# Certificate of Appropriateness

2779 N. SHERMAN BL.

PTS ID 115113 COA: CHIMNEY REPAIRS

Subject chimneys viewed from Hadley in 2014.

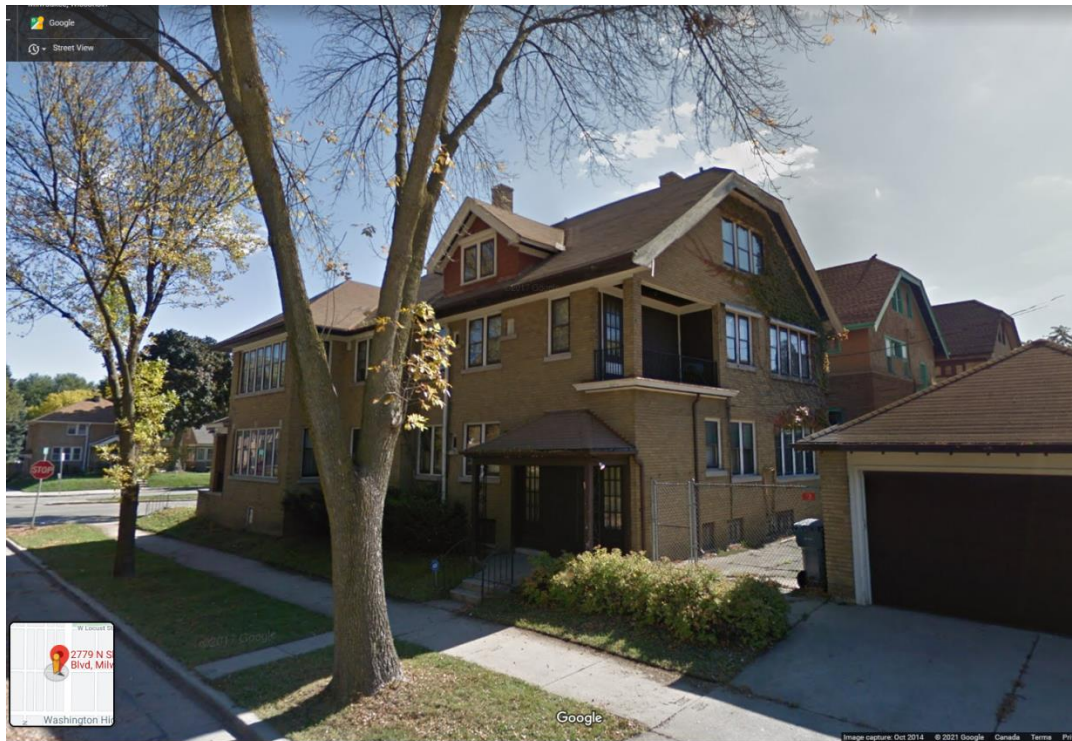
New mortar must match the original mortar in terms of color, texture, grain size, joint width, and joint finish/profile. The compressive strength of the repointing mortar shall be equal or less than the compressive strength of the original mortar and surrounding brick or stone. The replacement mortar shall contain approximately the same ingredient proportions of the original mortar. Mortar that is too hard is subject to premature failure and could damage the masonry. See the city's books *As Good As New* or *Good for Business*, Masonry Chapters, for more information. In most cases, this means a lime mortar with natural hydraulic cement rather than Portland cement. No joint of a width less than 3/8" may be cleaned of damaged/decomposed mortar with power disc grinders. No over-cutting of the joints is permitted. Remove decomposed mortar back into the wall 2.5 times the height of the joint before repointing. When installing new flashing at a masonry feature, the flashing must be stepped or cut into the mortar joints. The bricks may not be cut to install flashing at an angle.

**New brick must match as closely as possible the color texture, size, and finish of the original brick.**

**A sample panel of brick and mortar must be reviewed and approved by HPC staff prior to general installation of the material.**
